Docket Item # 2 BAR CASE # 2011-0042

BAR Meeting March 23, 2011

ISSUE:	Alterations (Retaining Wall and Portico)
APPLICANT:	Annette Wietecha
LOCATION:	415 North Payne Street
ZONE:	RB / Residential

Figure 5: Proposed plan/elevation.

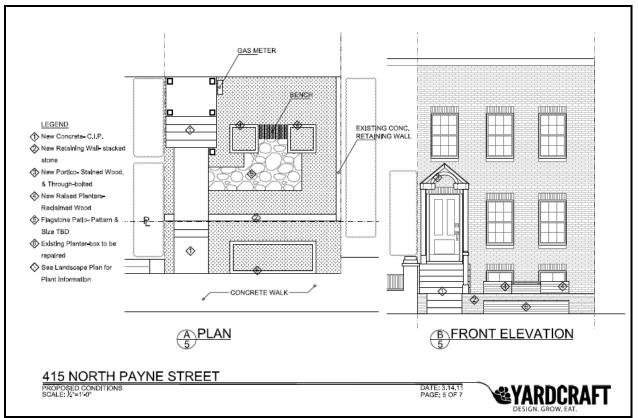
The proposed front gable portico is a Post-Modern, Colonial Revival style which is well proportioned but the wrong style for this particular house. In addition to functionally keeping rain off of your waiting guest's heads, a portico provides an aesthetic and welcoming focus for the façade of a house. Unfortunately, on this severely simple row of townhouses, the proposed design visually dominates the elevation. Staff has no objection to rain protection at the front door but cannot support this particular proposal.

As always, Staff continues to be concerned about the implications that approval of the proposed portico would have for future projects. There is potential for a sort of "embellishment creep" with this type of housing stock. There are many similar mid-20th houses in the historic district that could be made to look "prettier" and older by the addition of any number of add-on architectural features, such as door surrounds and window hoods, railings, awnings, shutters, cornices. Some of this has occurred in the past but staff does not recommend it on this relatively intact block of homes.

Although Staff does not support the construction of the proposed portico, Staff could support the installation of something more subtle and easily reversible, such as a fabric or glass and metal awning or of a thin cantilevered hood in a modernist style. The less expensive awning would address the applicant's immediate desire for protection from the weather, while providing only minimal and an easily reversible architectural embellishment to the front façade. Any awning proposed by the applicant should be reviewed and approved by Staff.

- 1. Approval of the stone retaining wall, concrete walk and stair;
- 2. Denial of the proposed front portico and railing and approval of a simple modernist awning and minimal handrail, to be reviewed and approved by Staff;
- 3. That the existing wood planter in the public right-of-way be removed by the applicant.
